A G E N D A

Architectural Review Board

March 28, 2023 – 5:30 p.m.

5A

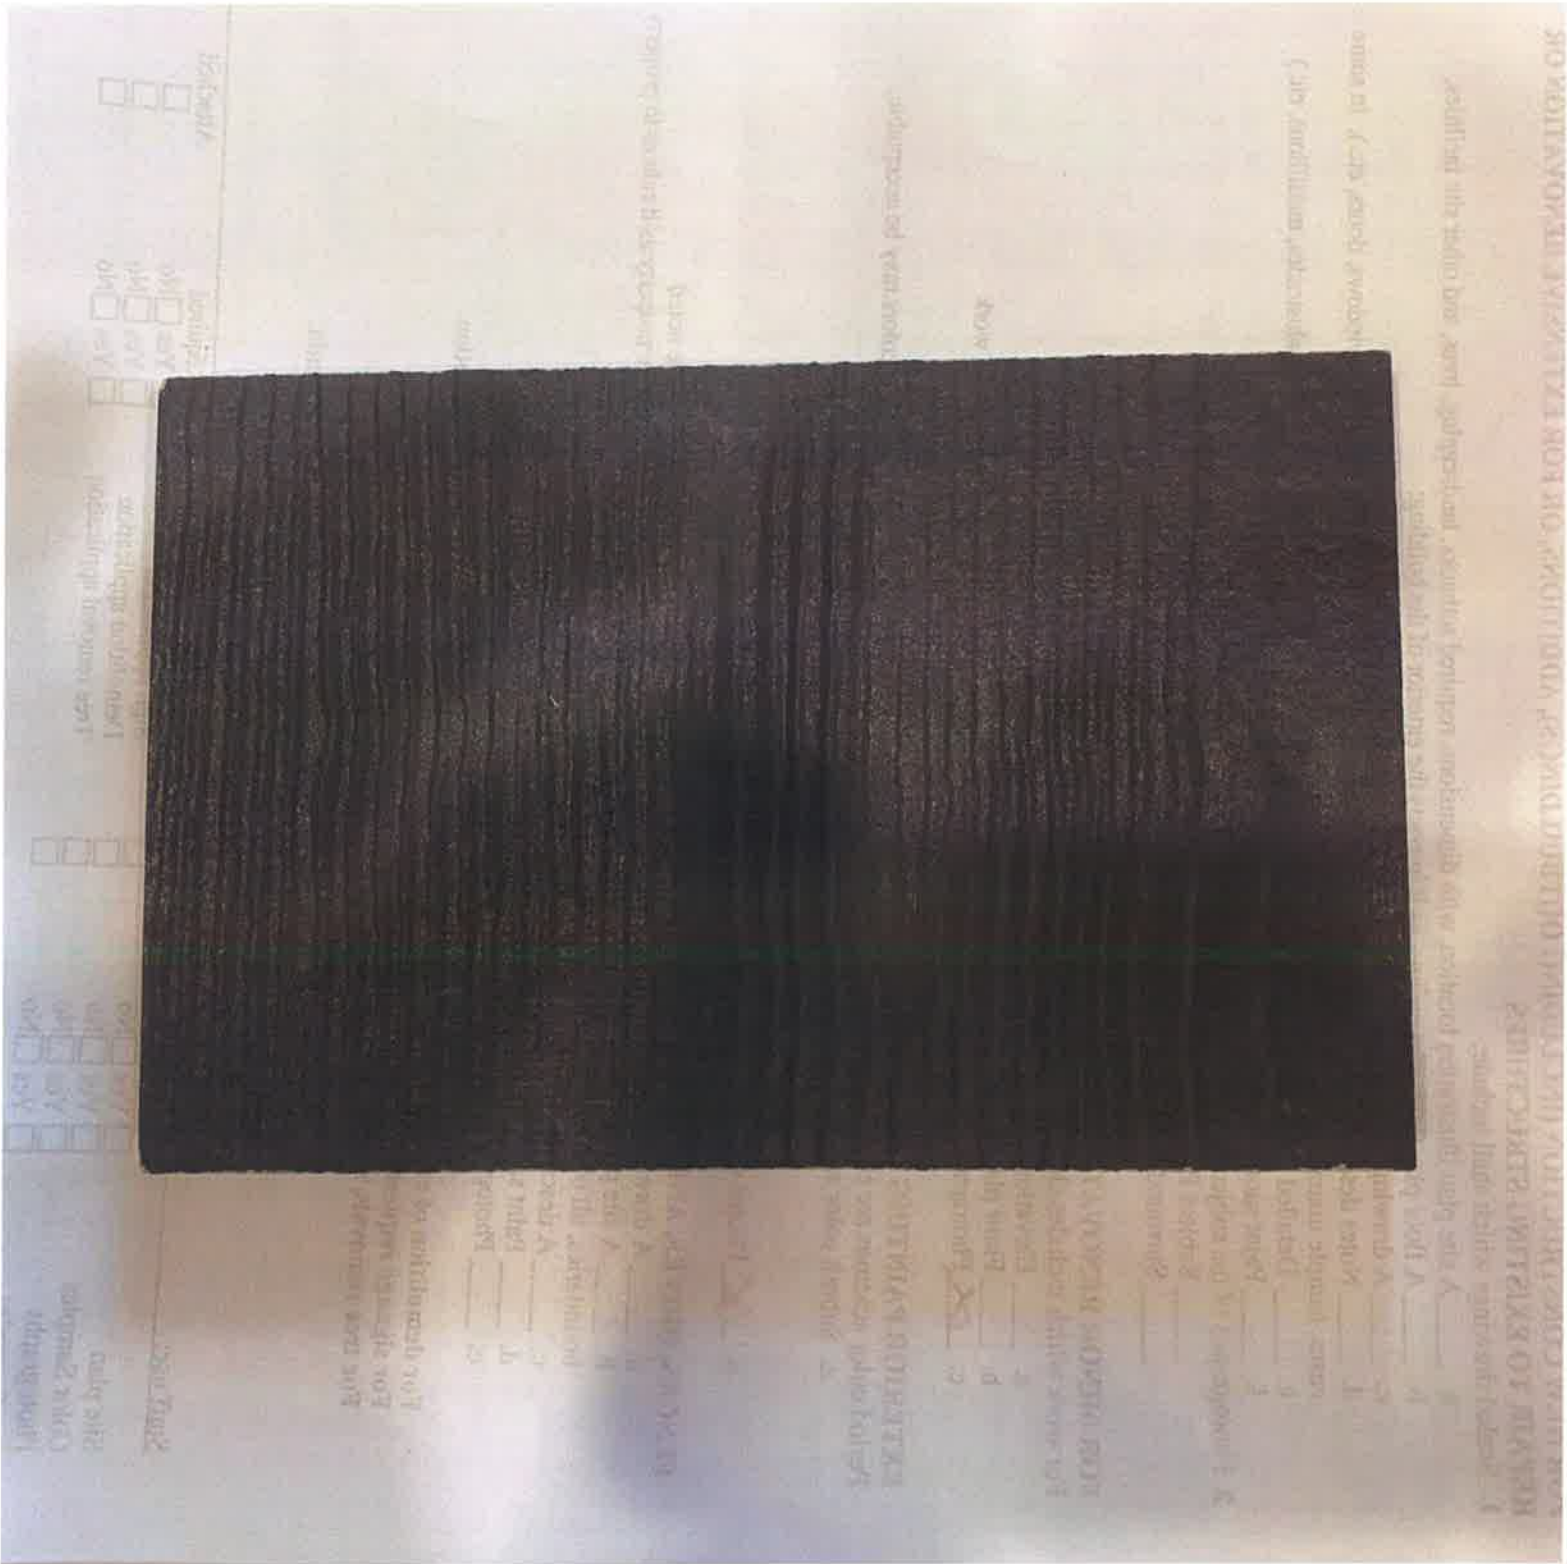
- The ARB has approved hardi-plank on new building and in areas not visible from the street but has not approved hardi-plank on the front of the house or areas visible from the street. The sample provided is not the same profile as the drop siding on the historic house, and it should match exactly.

6A

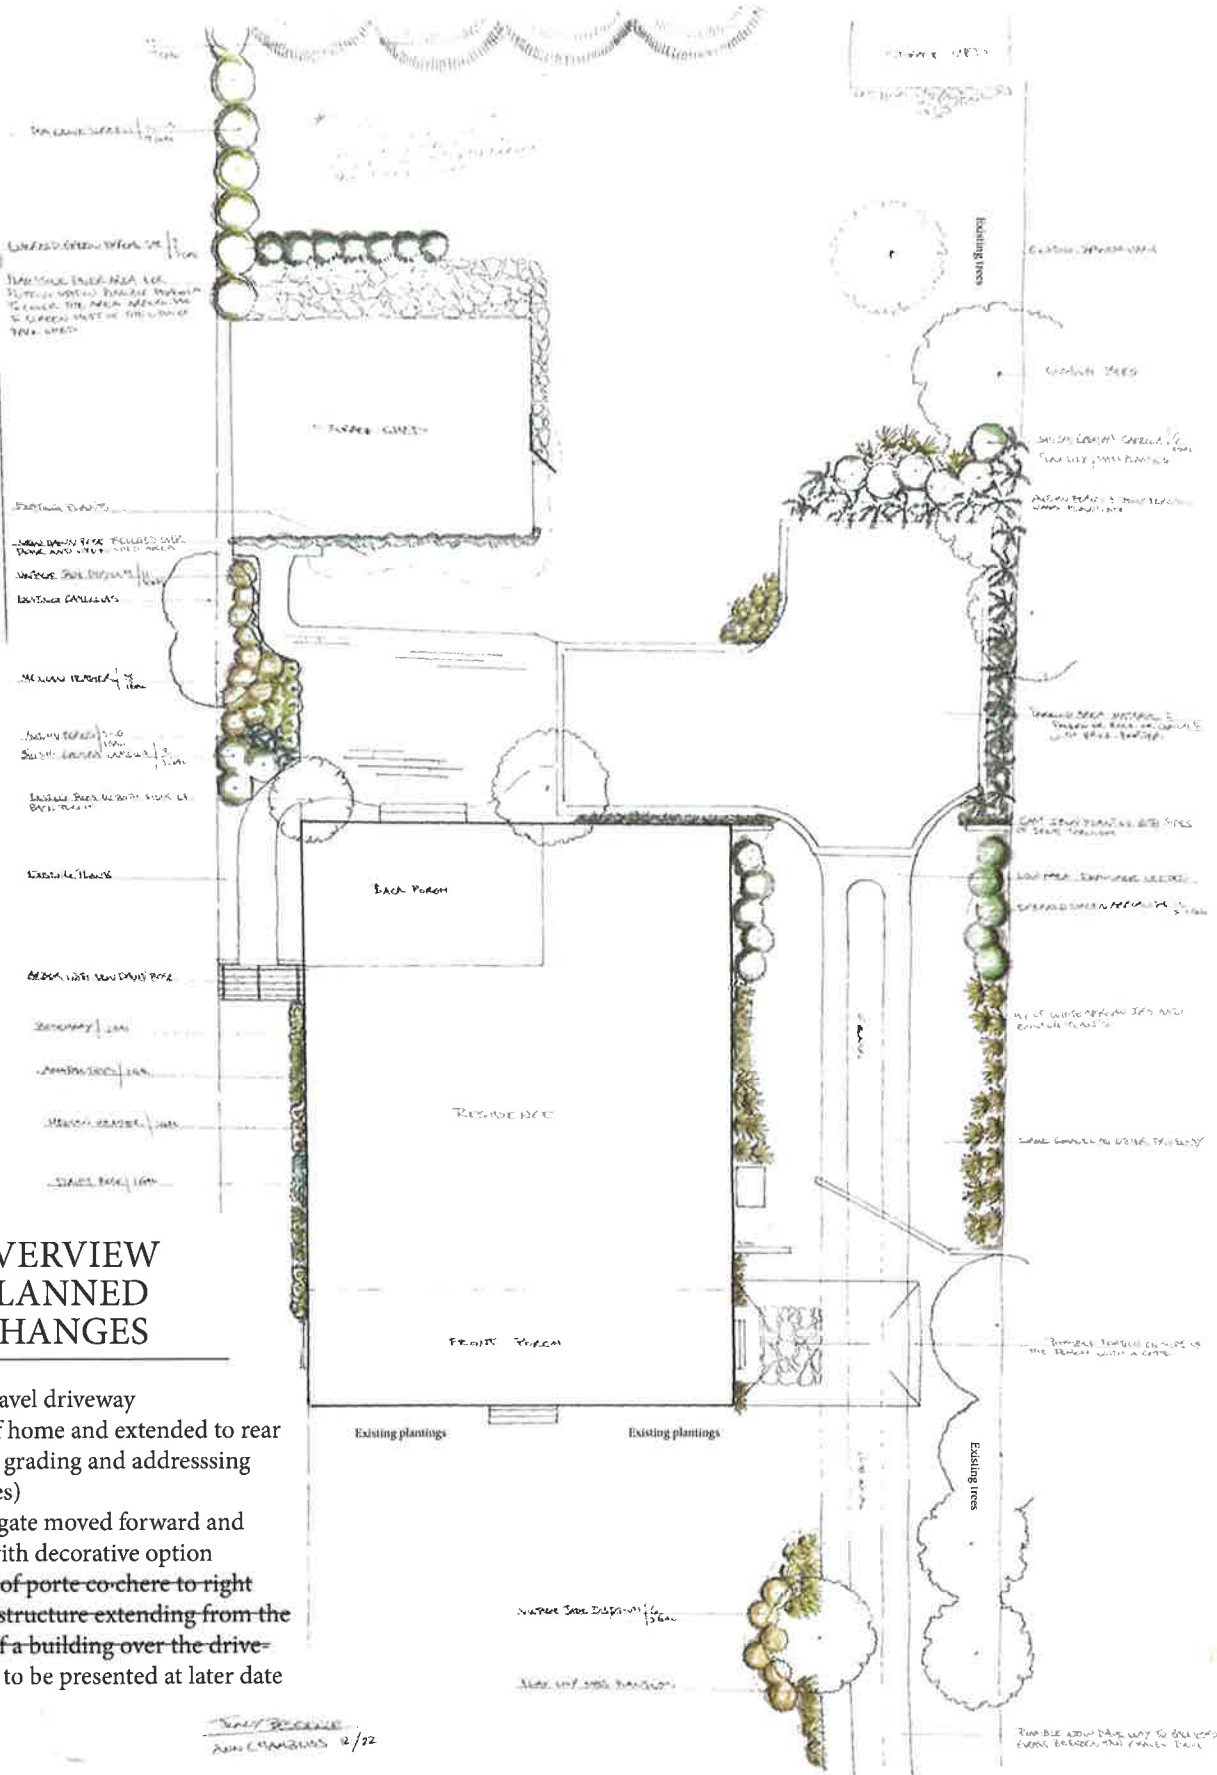
- Approval from Traffic Engineering would be required for the new curb cut.
- Grading between the trees in front will kill the trees.

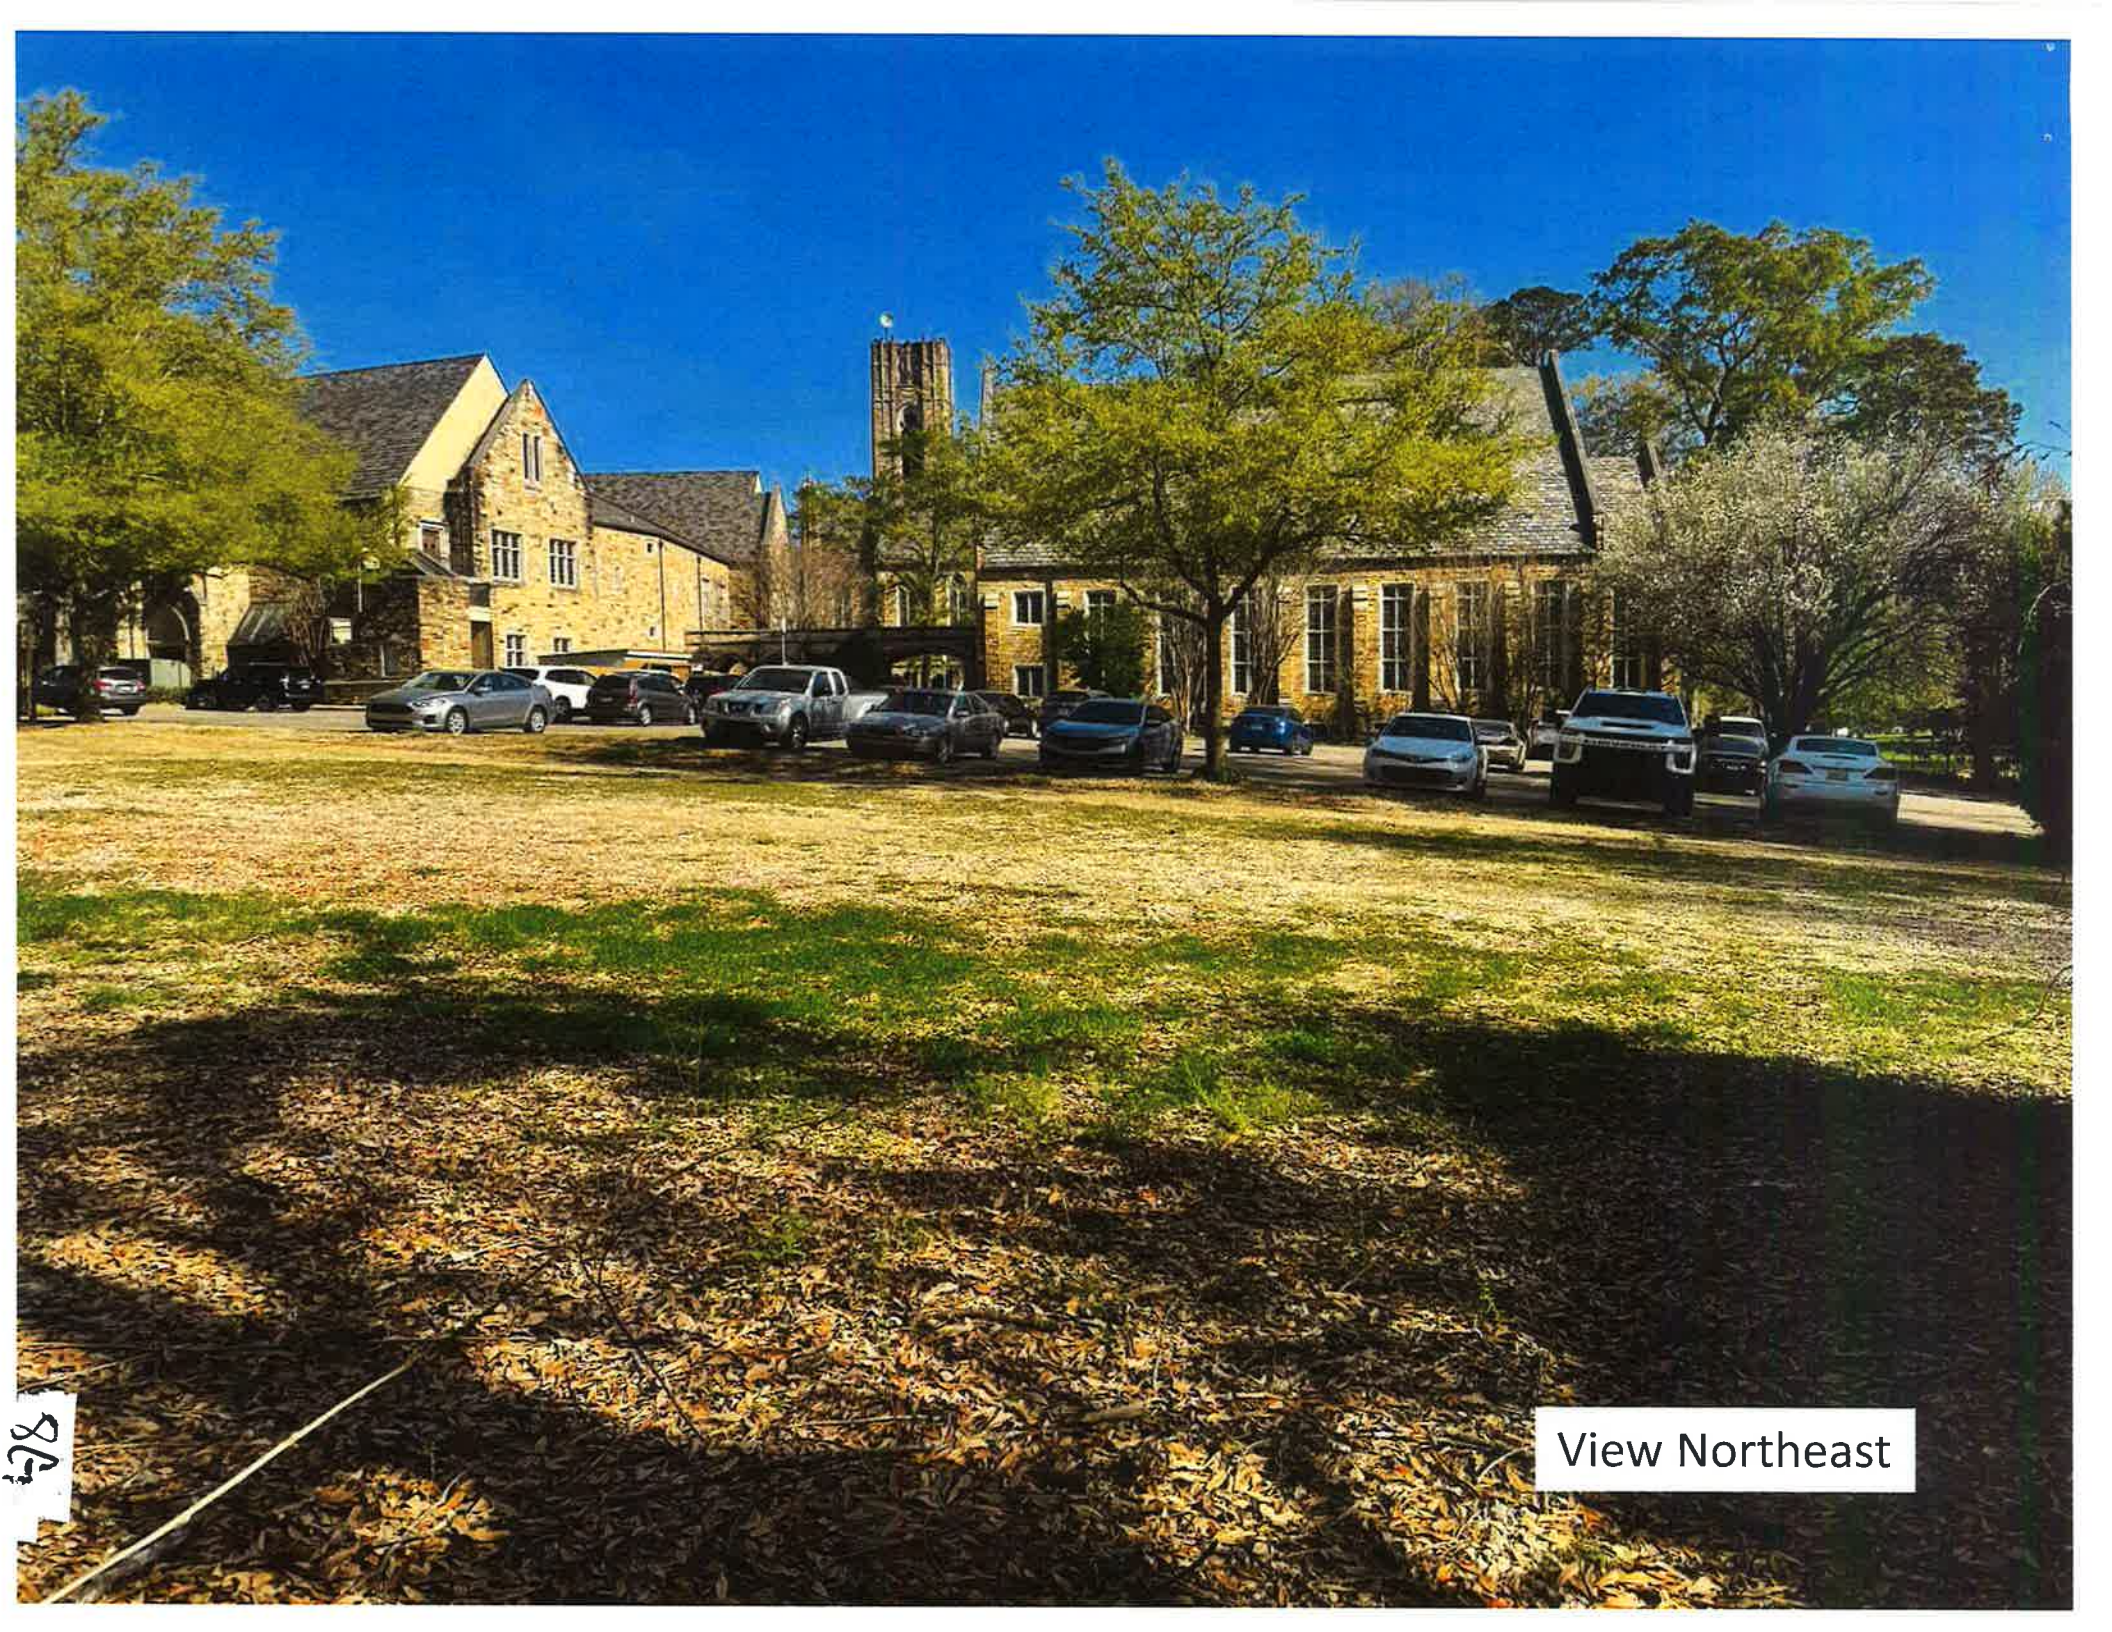
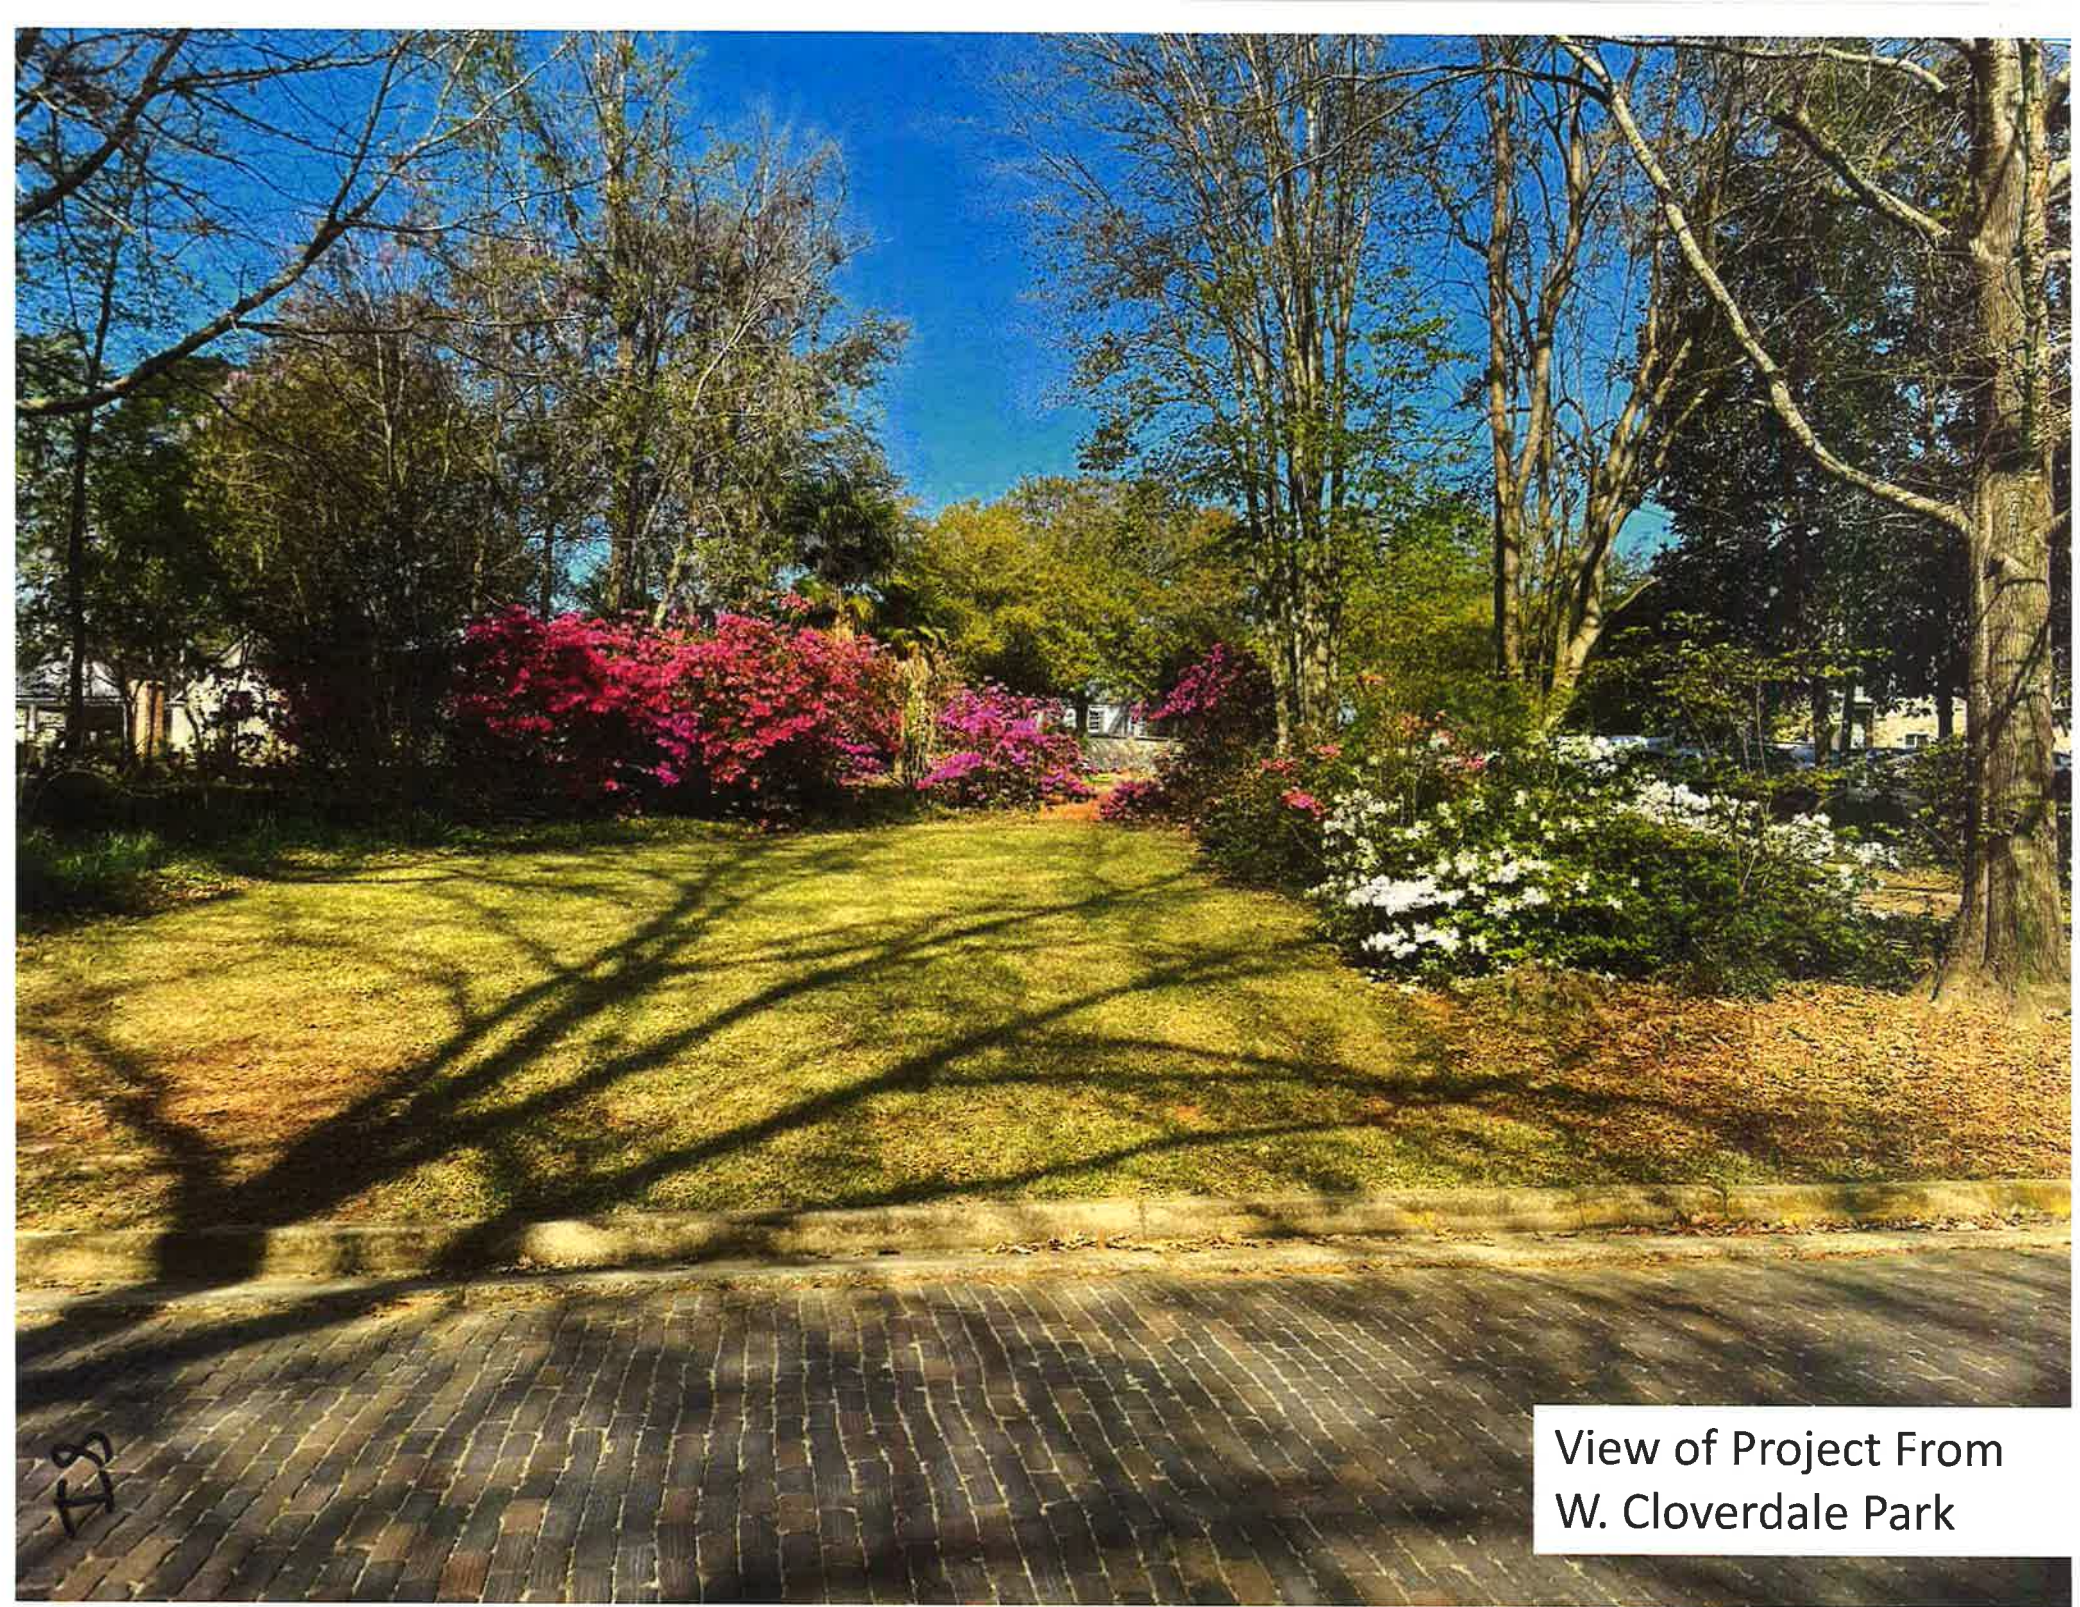
- Parking as proposed will be nearly invisible from the street.
